KAMIRA AVENUE VILLAWOOD

COUNCIL RFI - URBAN DESIGN REPORT

NOVEMBER 2022

BUILDING HEIGHT
SECTION

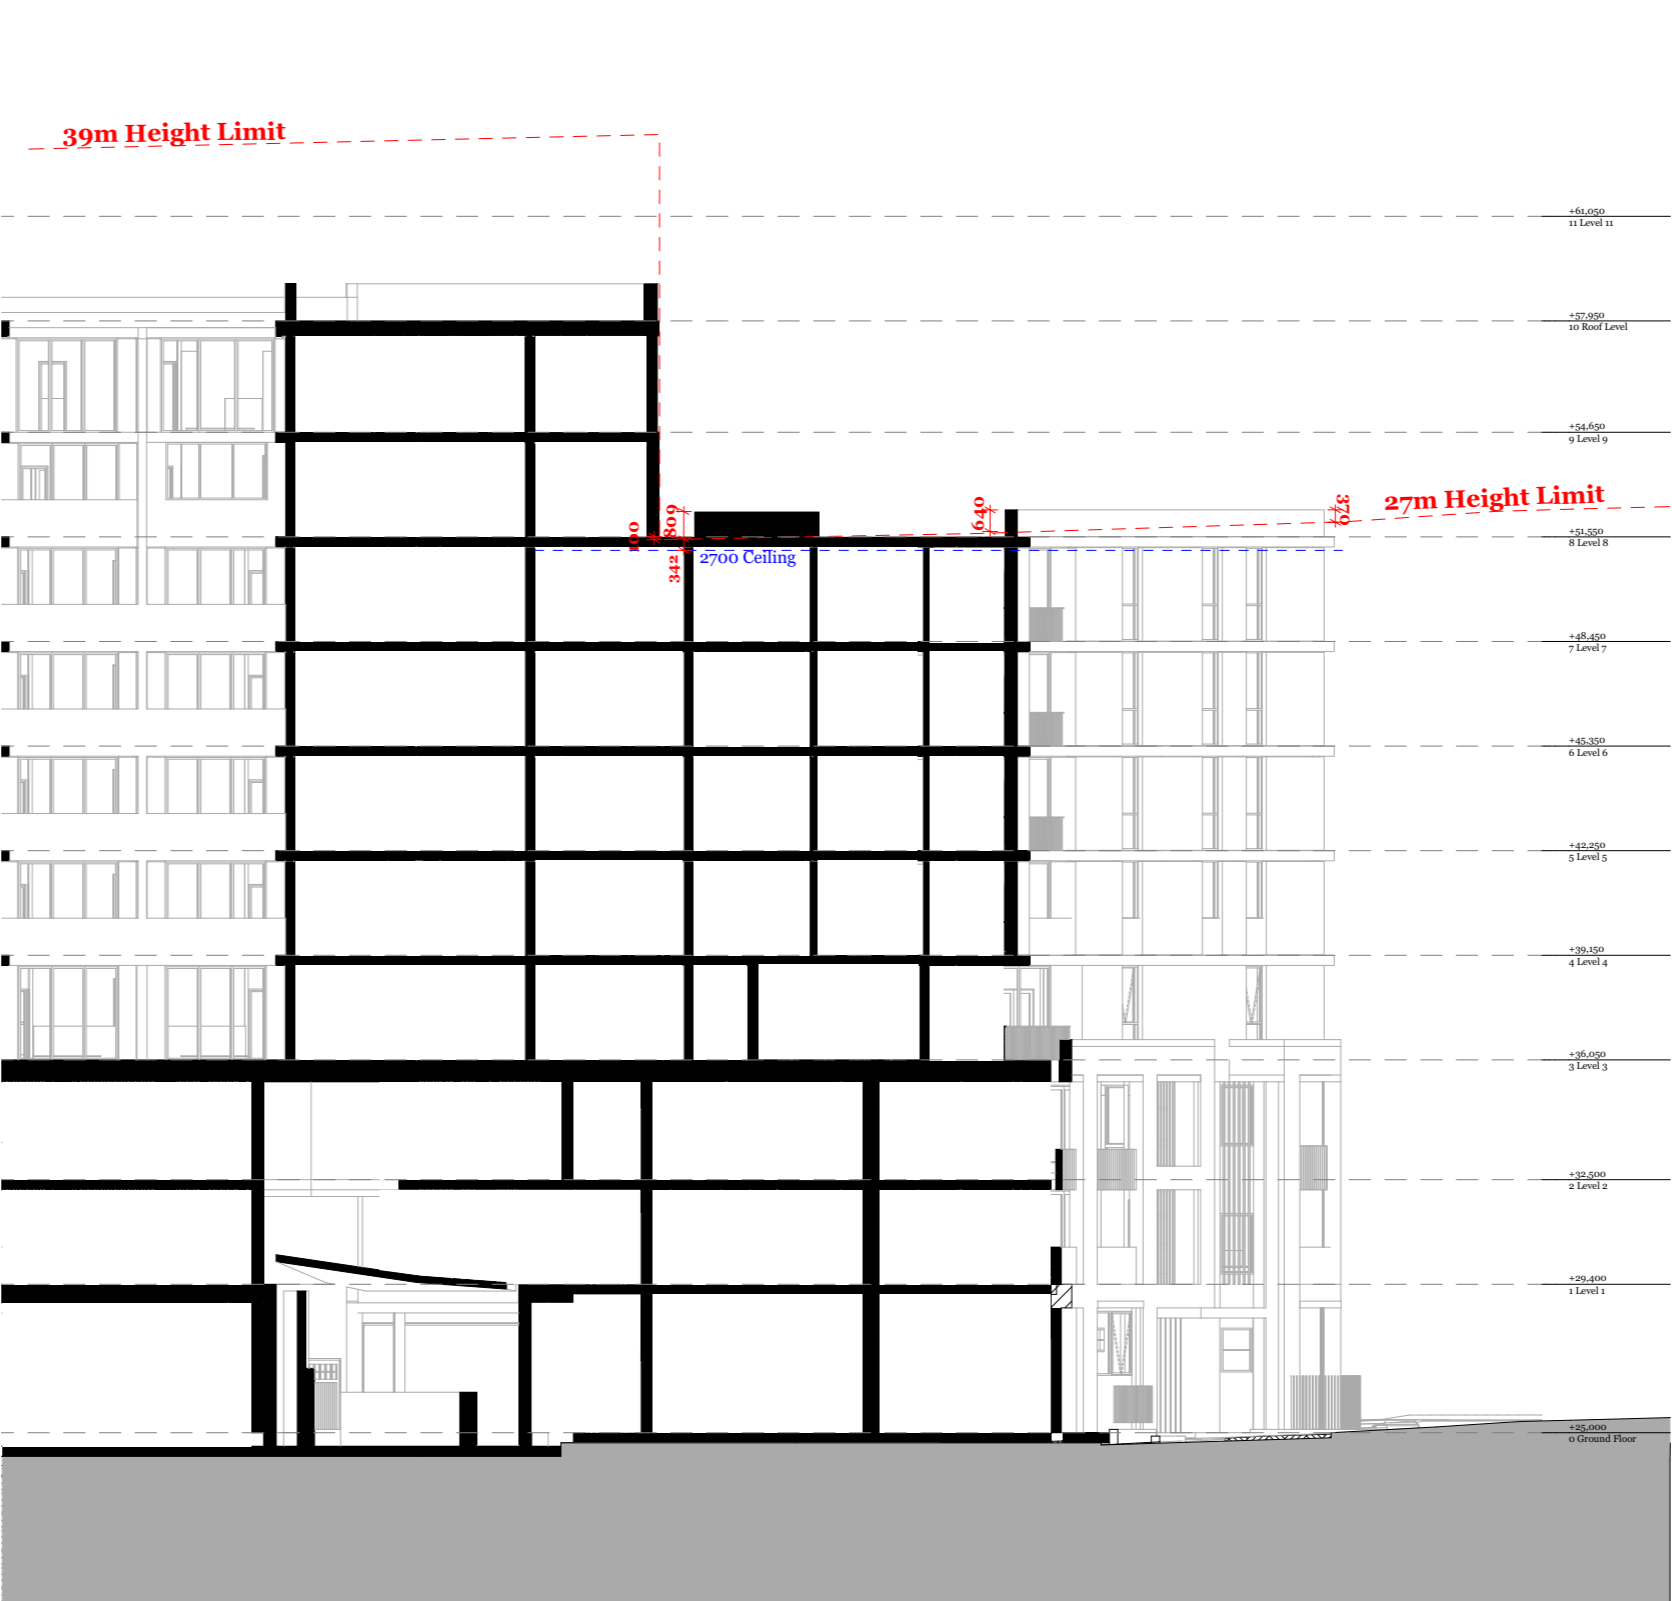
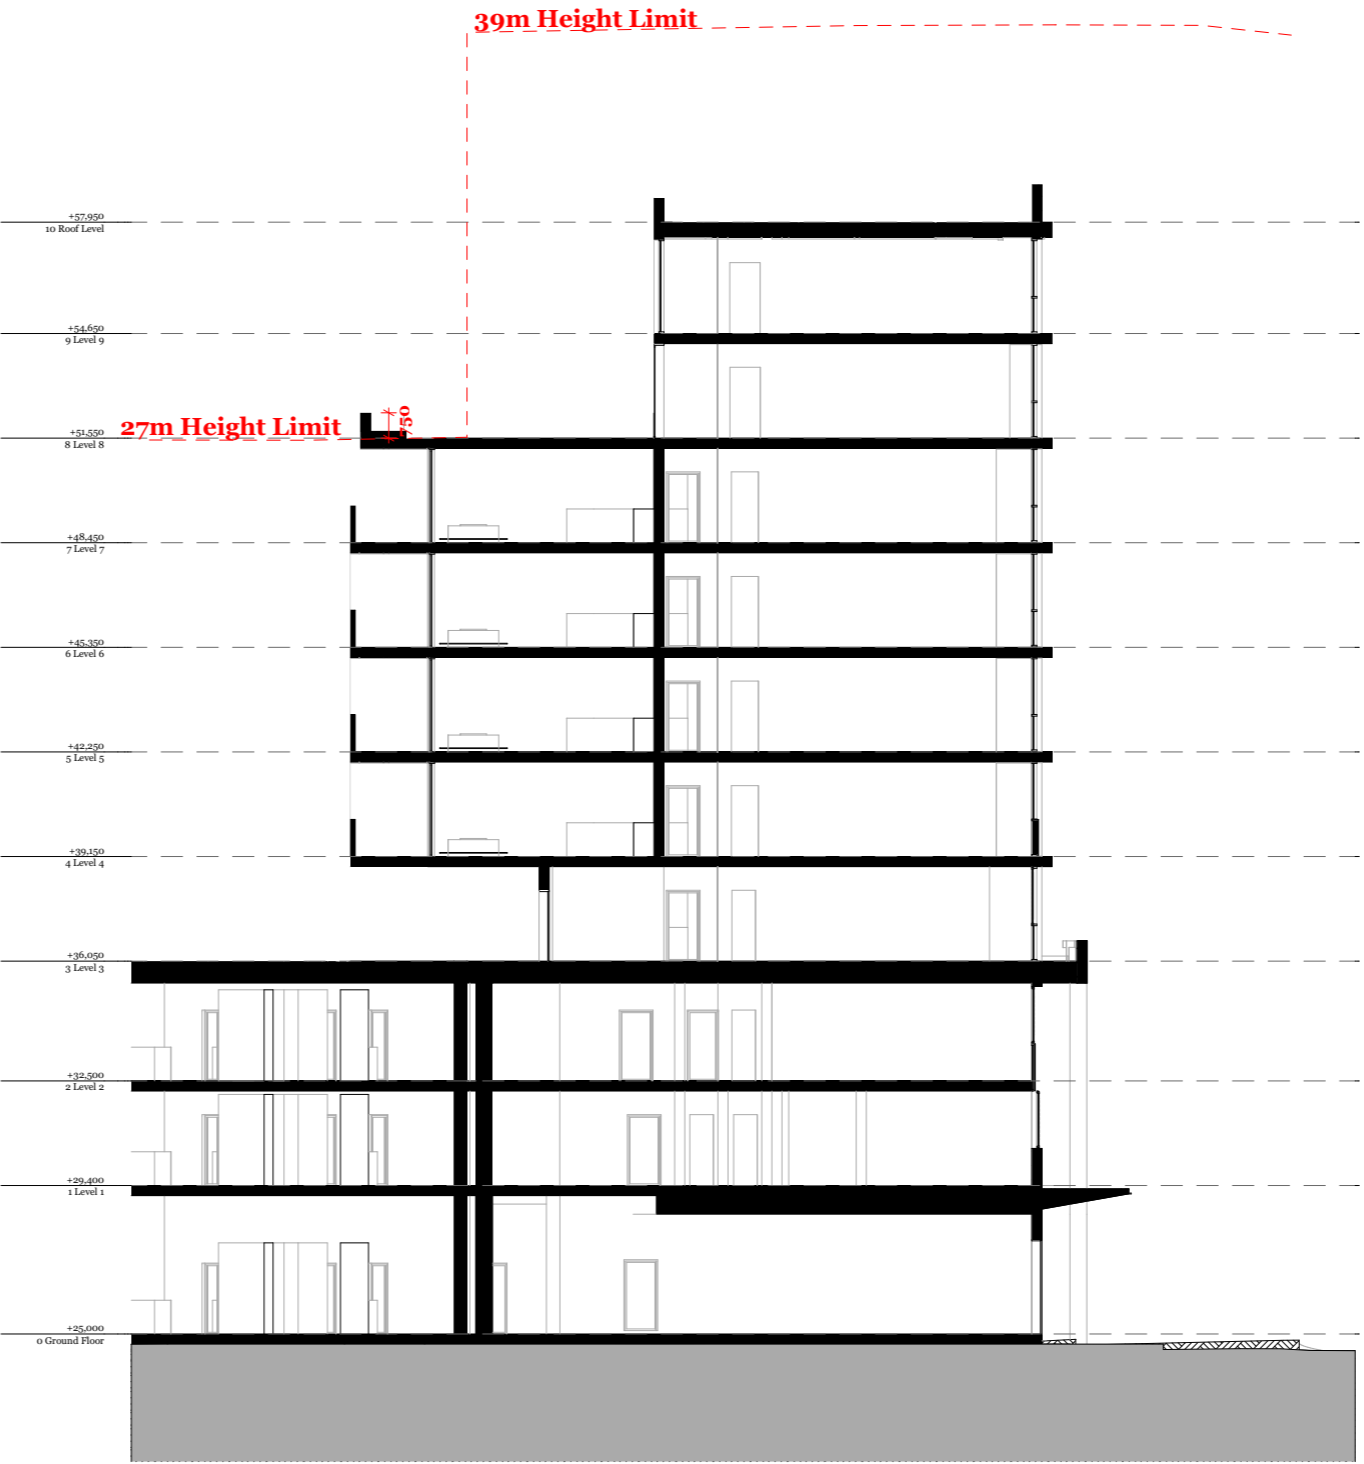
The application still proposes a non-compliance with the LEP 2013 building height due to the over-run of the parapet to Level 8 of the apartment building. Furthermore, the proposal involves an additional 2 storeys above what the Villawood DCP allows on the southern portion of the site

The majority of the proposed 10 storey building complies with the prescribed height control; however, the proposal does incorporate a minor variation to the building height control. The minor non-compliance is limited to the parapet to Level 8 to the 27m height provision, a maximum encroachment of 1800mm or 28.8m.

BALCONY USE

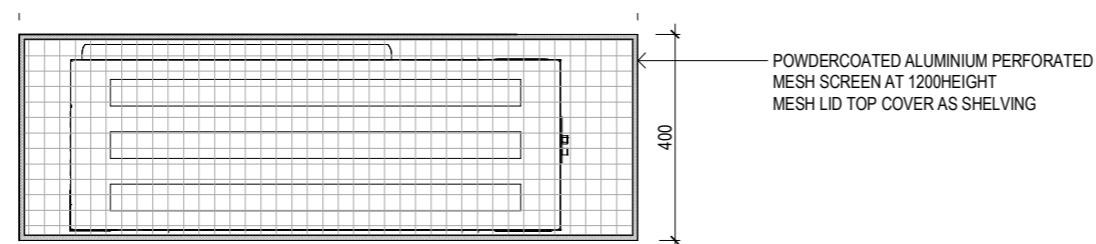
The plans shall indicate the location of all AC units and if located on balconies, indicate enclosed areas and impact upon POS areas.

The proposal incorporates pre determined location points and encasing design responses for A/C units on balconies. The location of the integrated units on the balconies are illustrated in the plans.

- All units are to be located on the floor of the private balconies, with no units hung from the walls.
- All units are located against the rear walls of the balconies to minimize their presence when viewed from the street, to ensure that they provide a functional addition to the balcony, and to maximise the balcony space for usable private open space.

- The units comprise powdercoated aluminium perforated mesh screen to a height of 1200mm. The coloured mesh screens the plant and integrates into the balcony design (as set out in the ADG)..
- The enclosure is fitted with a mesh lid top cover that provides a functional shelf to the balcony that allows for items such as a pot plant.

WINDOW SEPARATION

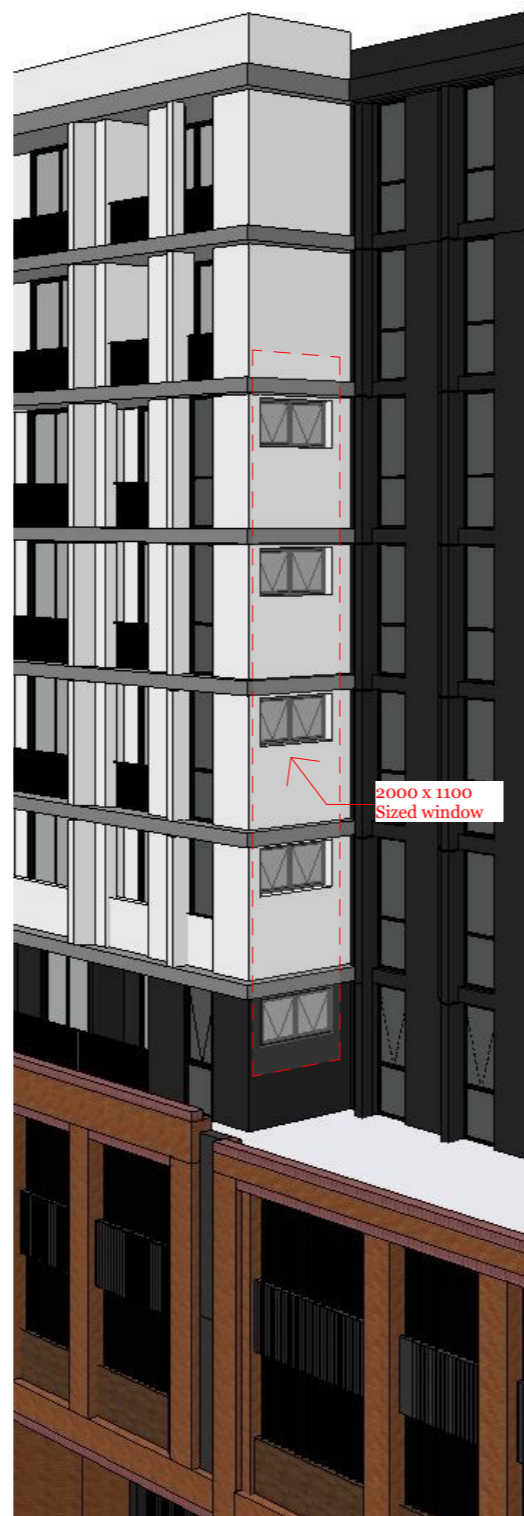
The applicant shall consider providing obscure or frosted glass to windows which face each other and have the potential to cause overlooking, for example windows to Units 307, 407, 507, 607 and 707 which face opposite windows to Units 313,413,513,613 and 713.

Between these units there is an adequate separation of 12,500 mm between the units.

Units 307, 407, 507, 607, 707

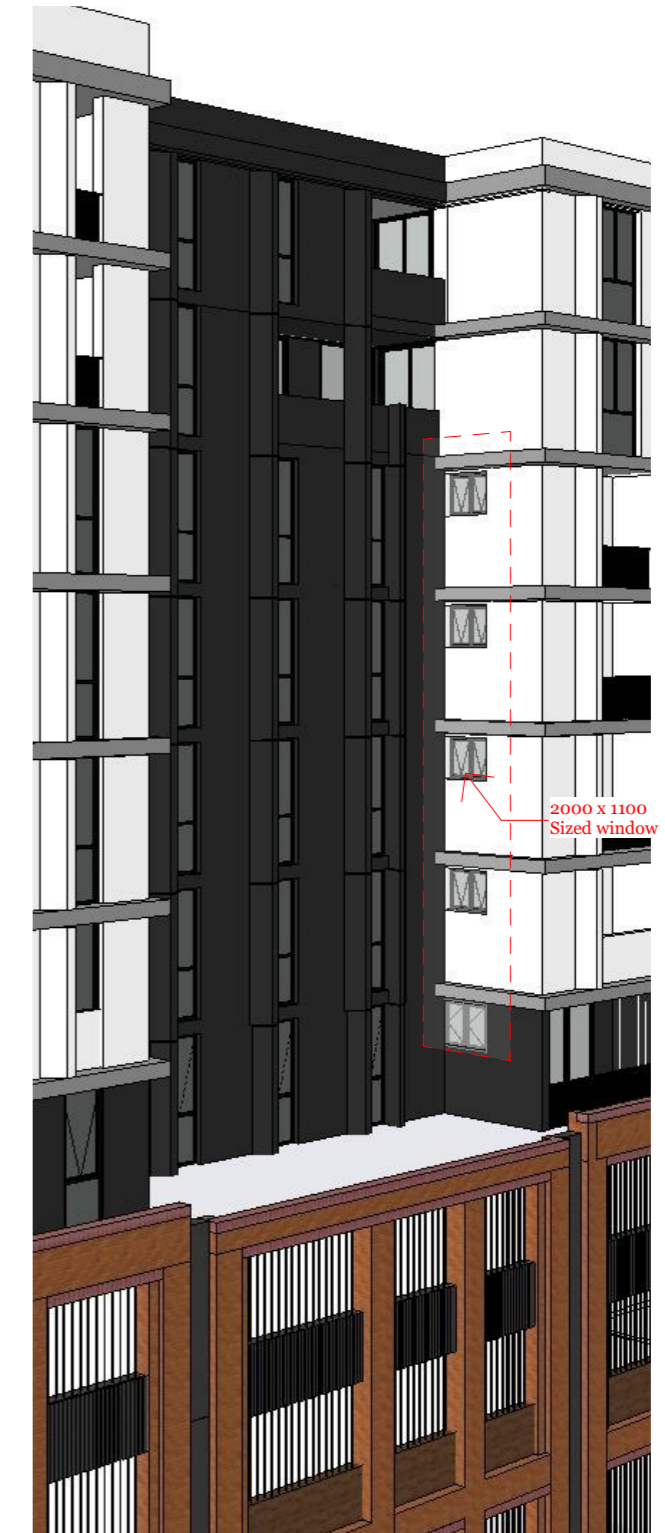
The applicant shall consider providing obscure or frosted glass to windows which face each other and have the potential to cause overlooking, for example windows to Units 307, 407, 507, 607 and 707 which face opposite windows to Units 313, 413, 513, 613 and 713.

The windows are 1100mm in height x 2000mm in width.

This high level window is situated at 1700mm from floor to sill level level to minimise any privacy concerns.
